TECHNICAL MEMORANDUM

TO: Paul Manzer, P.E.
Navix Engineering

JOB #: PACL.01.16

SUBJECT: Memo –Cilker Property Connection to Oakmead Stormwater Pump Station Data Review

Figure 1 - Cilker Property and Oakmead Pump Station Drainage

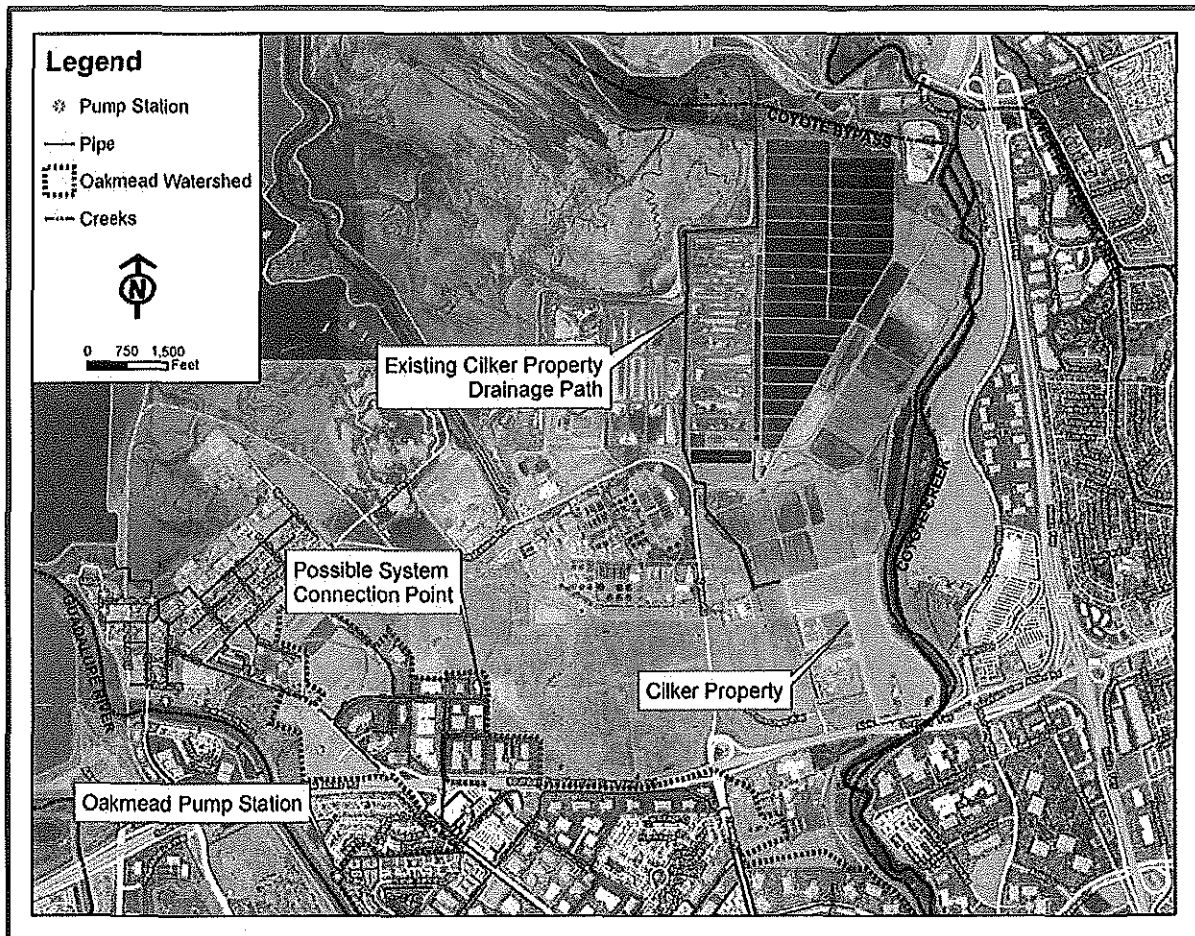
This memo summarizes the data reviewed to determine whether the Oakmead Stormwater Pump Station has adequate capacity to accommodate the Cilker Property project's post-development stormwater runoff. The site is currently not connected to the City of San Jose's storm drain system. It drains via sheet flow to a channel at the northwest corner of the property which passes through the San Jose Water Pollution Control Plant site and confluences with Coyote Creek. The developer originally proposed draining the site to Coyote Creek through a new outfall, but the City and Santa Clara Valley Water District have expressed concerns about the construction of a new outfall and altering the discharge location of the site. The City has asked the developer to review available data and determine whether directing flows to the Oakmead Pump Station by connecting site piping to the City's storm drain system at Nortech Parkway is feasible.

The Oakmead Pump Station does have adequate capacity for the addition of flows from the Cilker Project Area, but will then be functionally at capacity. If the site is connected to the City's system at Nortech Parkway then the City should ensure that any development that occurs between the site and the connection point in Nortech Parkway drains to a different pump station or outfall. An analysis should be completed to ensure that the storm drainage system between Nortech Parkway and the Oakmead Pump Station has sufficient capacity.
